# Marion County

## Development Review Committee

### Meeting Agenda

**Monday, April 6, 2026**

SHEET NUMBER  
C004

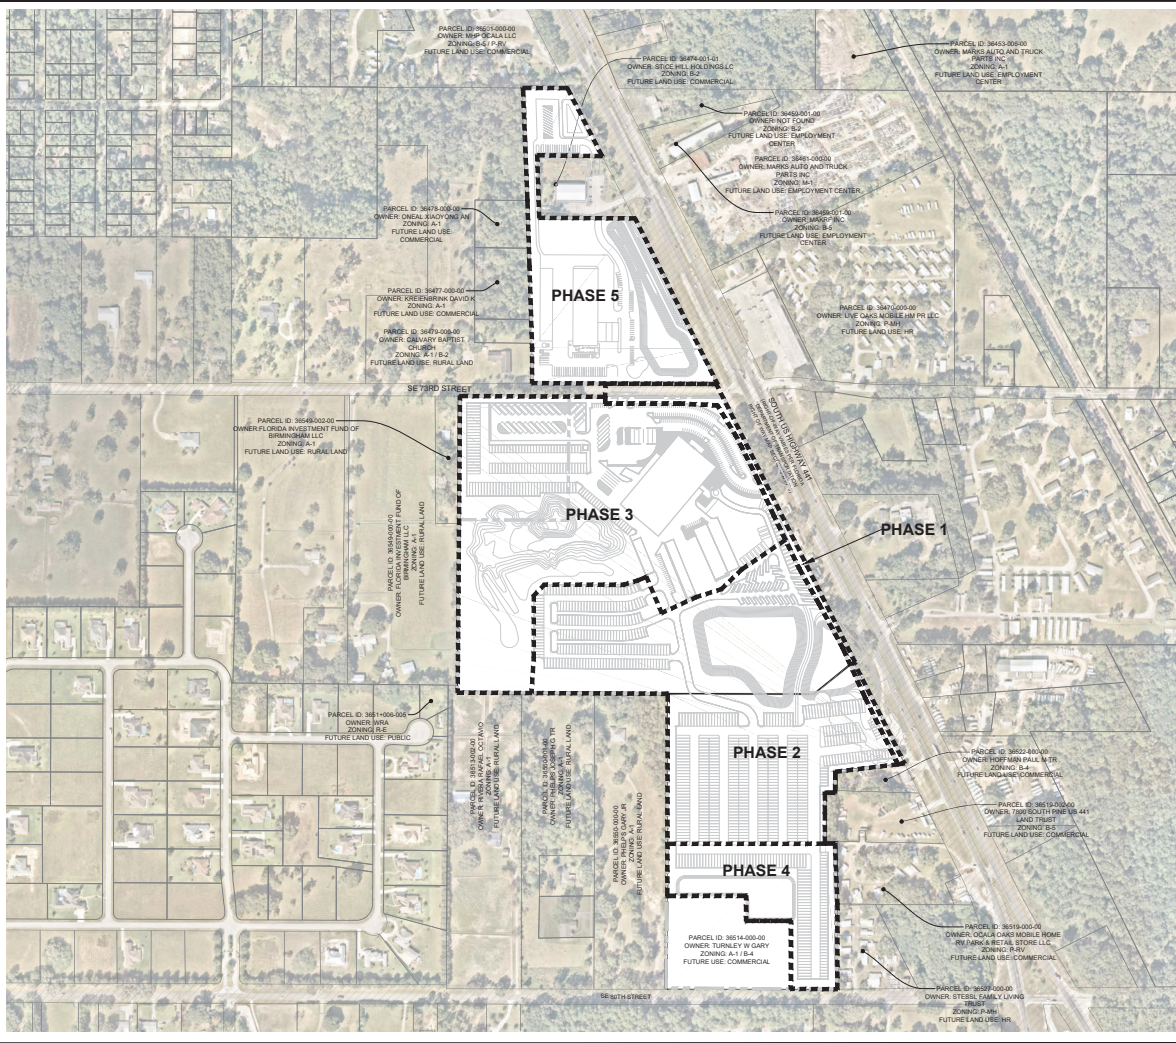
<i>Corrections</i>	2.12.24 - Landscape requirements/6.8.6 - Buffering (Not Resolved) - [3/16/26] Number 1 and 2 have been satisfied. Number 2 is acknowledged to be provided at time of site plan. Per Table in Condition 7, entire west boundary buffers (including along residential and ag tracts) shall be up to 50' in width. Only 30' is provided along select ag parcels. Please correct. [INITIAL] Three buffer plan sheets were submitted, two of which seem to be duplicates? (1) South boundary of north area and north boundary of south area is required to provide MODIFIED Type C buffer; LDC Type C buffer is indicated. Please correct. (2) West boundary of north area is required to provide modified 20' Type B buffer without wall or 15' Type D buffer with wall; buffer plan sheet indicates buffer type I is 20' buffer or 15' Type B buffer? Please specify what type of buffer is provided alongside adjacent Calvary Missionary Baptist Church and provide letter from church supporting buffer type. (3) West boundary of south area is required to provide 50' no-touch buffer; only 30' buffer is indicated. Please correct.
